The Leicestershire County Council (A606 North and East Melton Mowbray Distributor Road) Compulsory Purchase Order 2020 (“CPO”)

The Leicestershire County Council (A606 North and East Melton Mowbray Distributor Road) Side Roads Order 2020 (“SRO”)

Your client: Jelson Limited (“Jelson”)

TYPICAL CROSS SECTIONS - SECTION 3 MAINLINE - CH3300, drawing
number [REDACTED]

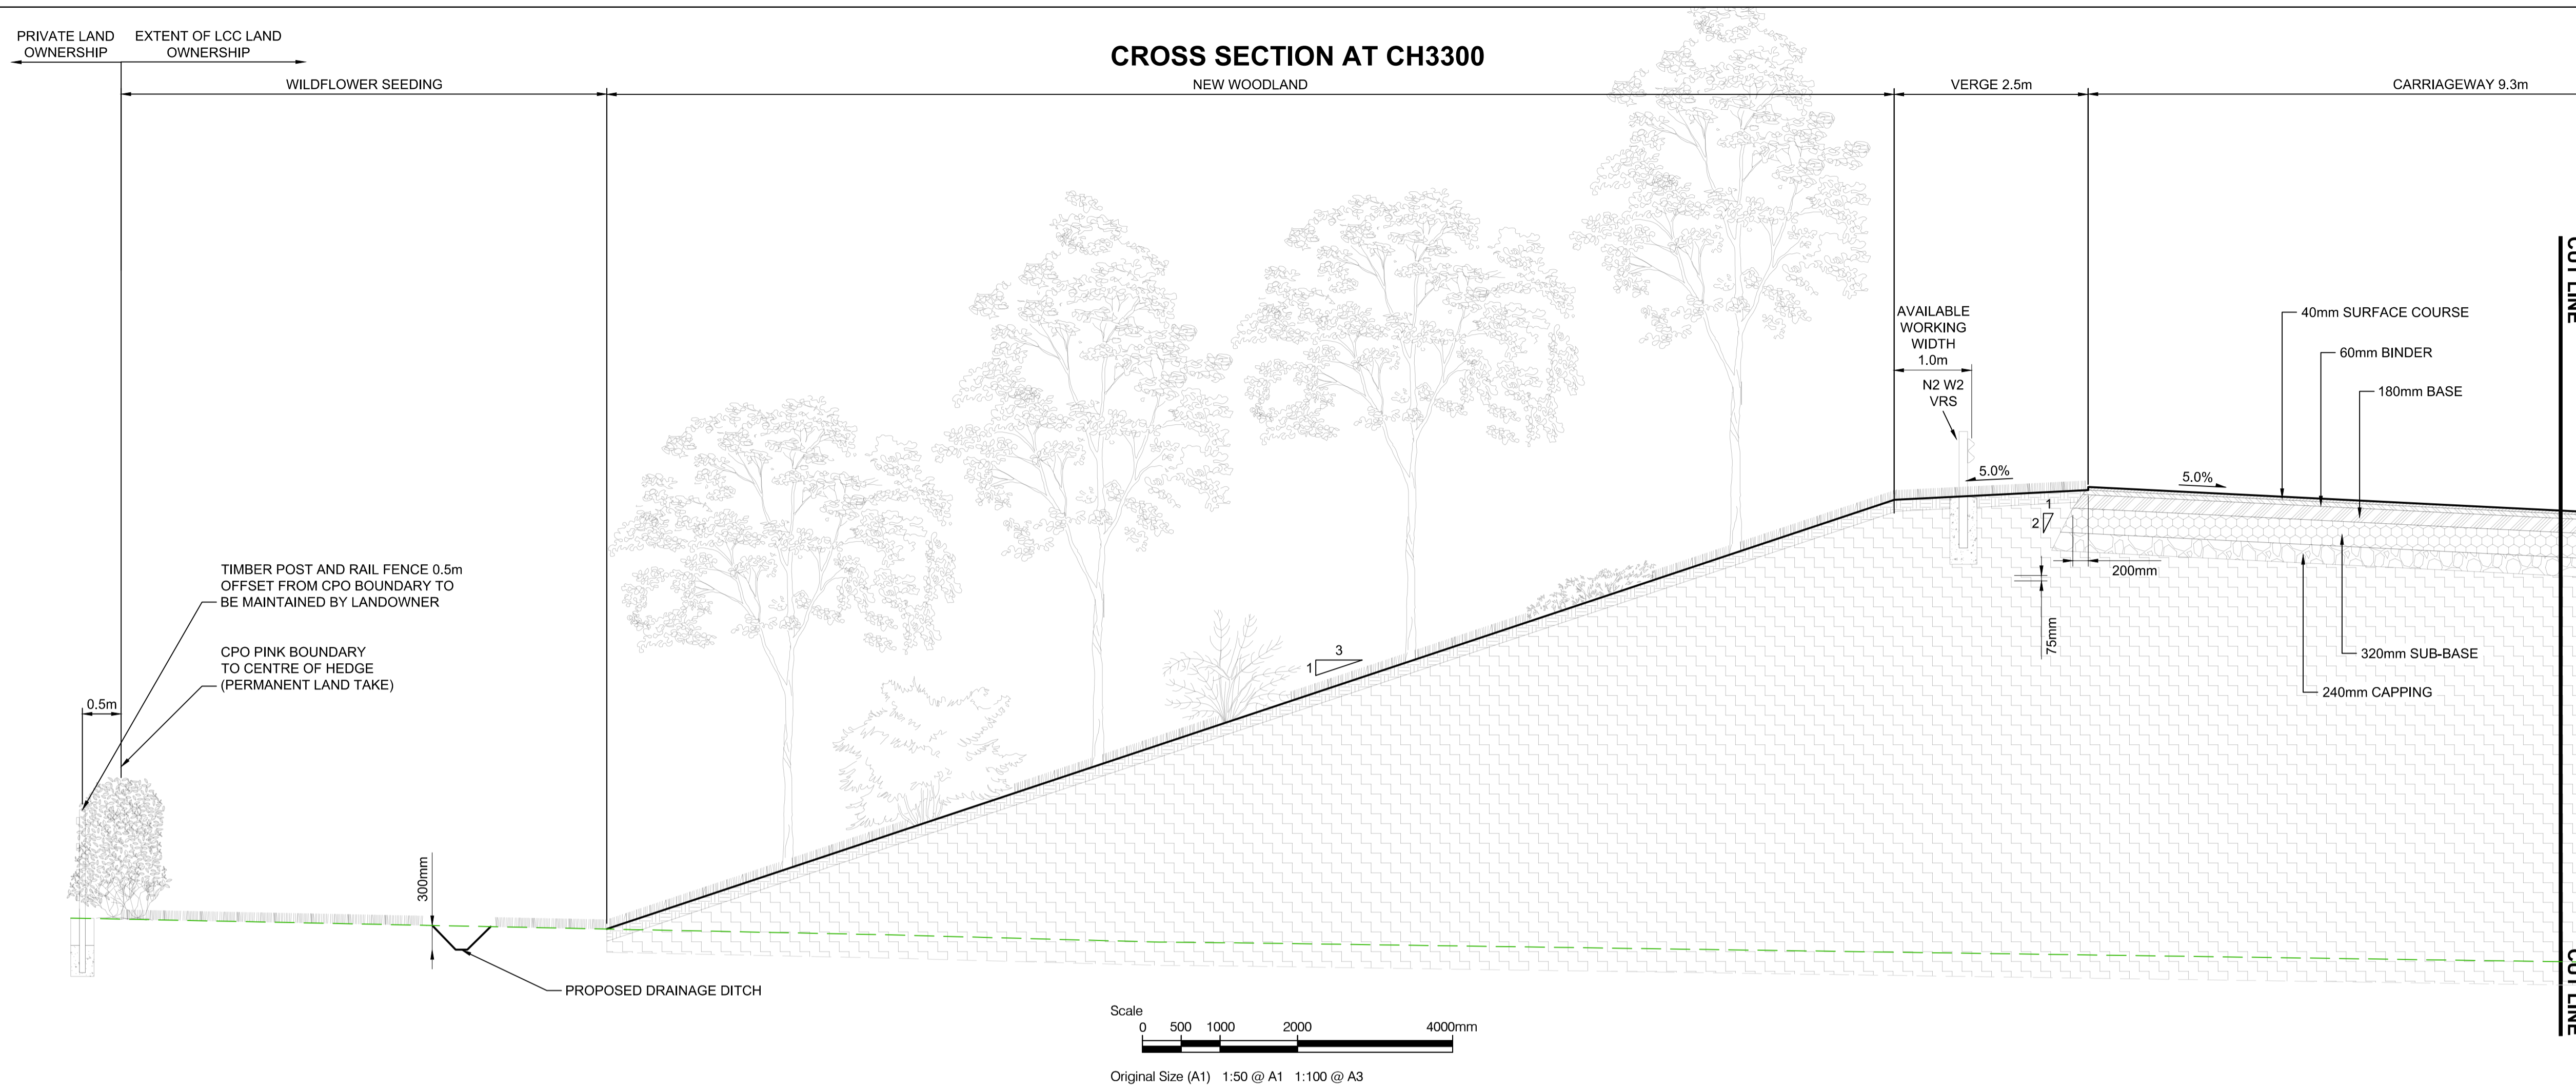
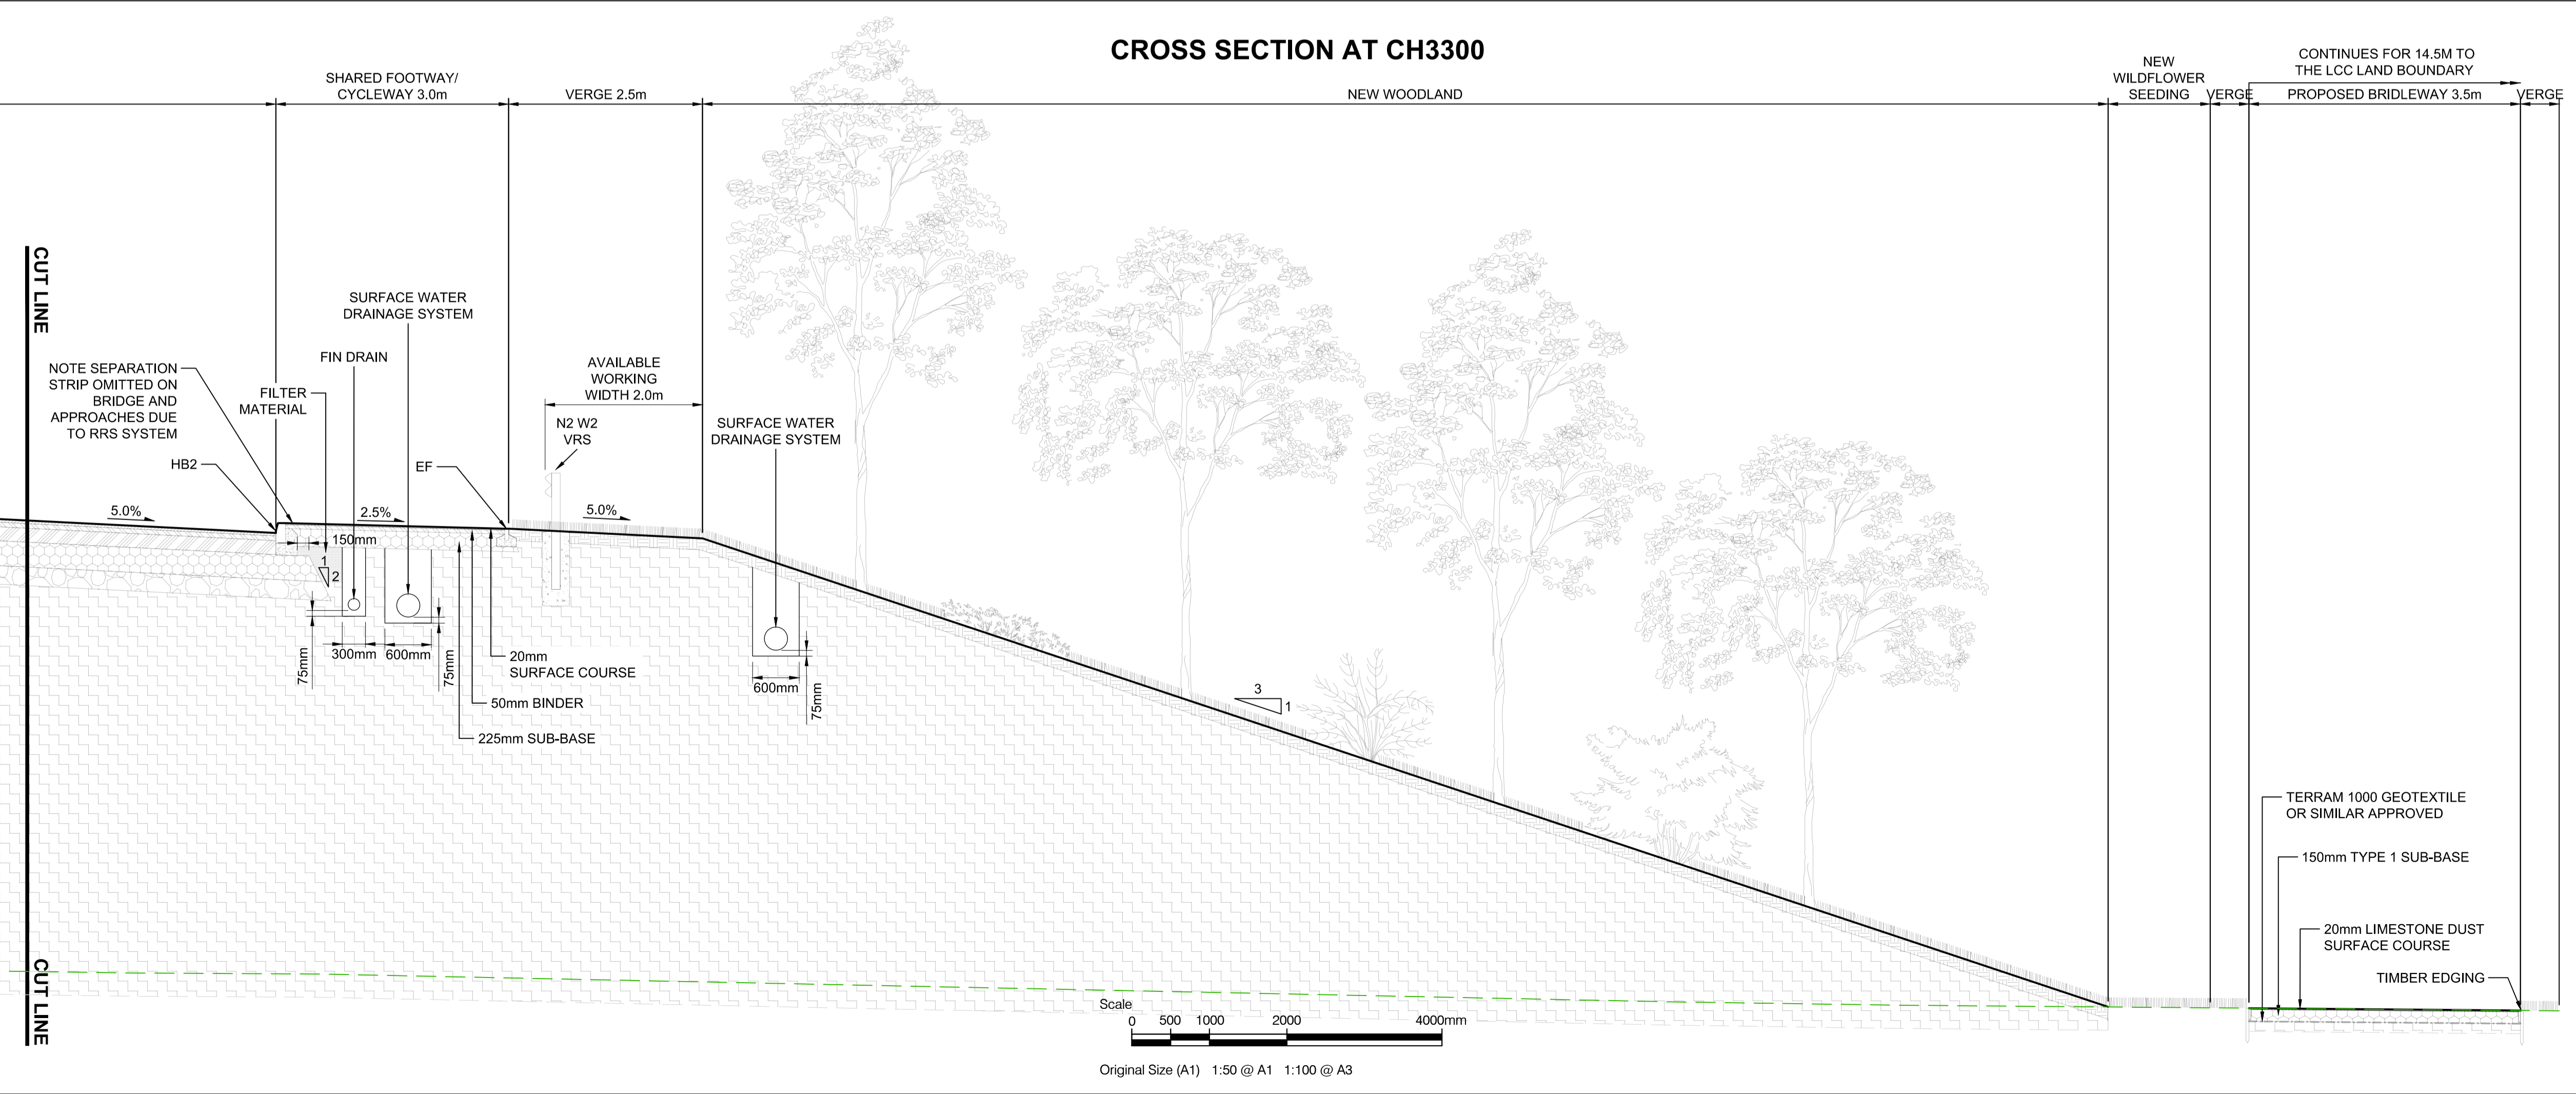
- 1.4. The Council remain committed to securing Jelson's interests in the land by agreement and are open to negotiation.
2. Your second objection is that the proposed land take is excessive; in Plots ■ and ■ appearing sufficient to deliver a dual carriageway road on a very shallow embankment.

- 2.1. The NEMMDR is a single carriageway road that has been designed in accordance with the Design Manual for Roads and Bridges to achieve, as far as is possible, an earthwork cut / fill balance. This minimises the need to import or export large quantities of material, thereby achieving a cost-effective and environmentally sustainable construction and reducing disruptive construction traffic impacts. In this location, the vertical alignment is further predicated on the tie-in with the existing highway network at Melton Spinney Road to the west and the culverting of Thorpe Brook to the east.

- 2.2. The embankments are near the maximum permitted incline, stipulated by virtue of both geotechnical design and future maintenance requirements in accordance with the Construction (Design and Management) Regulations 2015. Attached to this response in Appendix A is a plan which shows a typical cross section adjacent to Plot ■. This plan illustrates the construction of the road and the embankment and is provided to aid your understanding of the requirement for the extent of the land take in this location.

- 2.3. The location of the attenuation pond on the south side of the NEMMDR is necessitated by the superelevation of the road which falls north to south.
